DART AEROSPACE LTD	Work Order:	149845
Description: Crosstube Assembly	Part Number:	D407-667-145
Inspection Dwg: D407-667-145 Rev: C		Page 1 of 2

DRAWING NO. D407-667-145	TITLE CROSSTUBE ASS'Y (407 HIGH FWD)	REV. C	DART AEROSPACE LTD ENGINEERING ORDER		D.E.O. NO. D407-667-145-C-1	SHEET NO. SHEET 1 OF 1	SCALE NTS
DRAWN 97	CHECKED ASS	MFG. APPR. 12	APPROVED WD		DE APPR. H		
DATE 11.07.15	DATE 11.07.22	DATE 11.07.22	DATE 11/07/22		DATE 11.07.21

DRAWING NO. D407-667-145	TITLE CROSSTUBE ASS'Y (407 HIGH FWD)	REV. C	DART AEROSPACE LTD ENGINEERING ORDER		D.E.O. NO. D407-667-145-C-2	SHEET NO. SHEET 1 OF 1	SCALE NTS
DRAWN AJS	CHECKED [Signature]	MFG. APPR. [Signature]	APPROVED [Signature]	DE APPR. [Signature]			
DATE 12.08.02	DATE 12.08.02	DATE 12.08.02	DATE 12.08.02	DATE 12.08.02	DATE 12.08.02

DETAIL P
BONDING STRAP INSTALLATION 2 PL

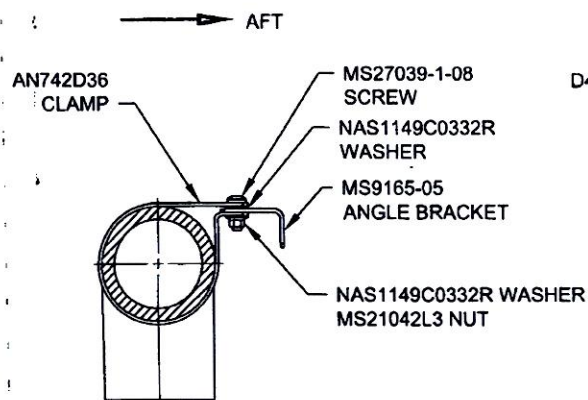
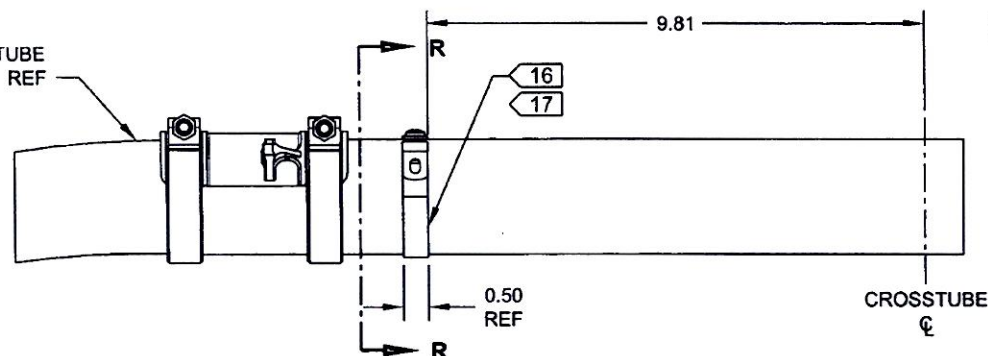
ADD ELECTRICAL GROUNDING STRAP

ITEM	QTY -145	PART NUMBER	DESCRIPTION
1	X	D407-667-145	CROSSTUBE ASSEMBLY (407 HIGH FWD)
10	2	AN742D36	CLAMP
11	2	MS9165-05	ANGLE BRACKET
12	2	MS21042L3	NUT (OR MS21042-3)
13	2	MS27039-1-08	SCREW
14	4	NAS1149C0332R	WASHER (OR AN960C10L)

- 16) MASK AREA UNDER CLAMP PRIOR TO PAINTING
- 17) SEAL EDGES WHERE AN742D36 CLAMP MEETS WITH THE CROSSTUBE USING SIKAFLEX-241/-291 OR MIL-S-8802 CLASS B2 OR PROSEAL 890 SEALANT
- 18) PERFORM RESISTANCE CHECK TO ENSURE MAX RESISTANCE IS 10 MILLIOHMS
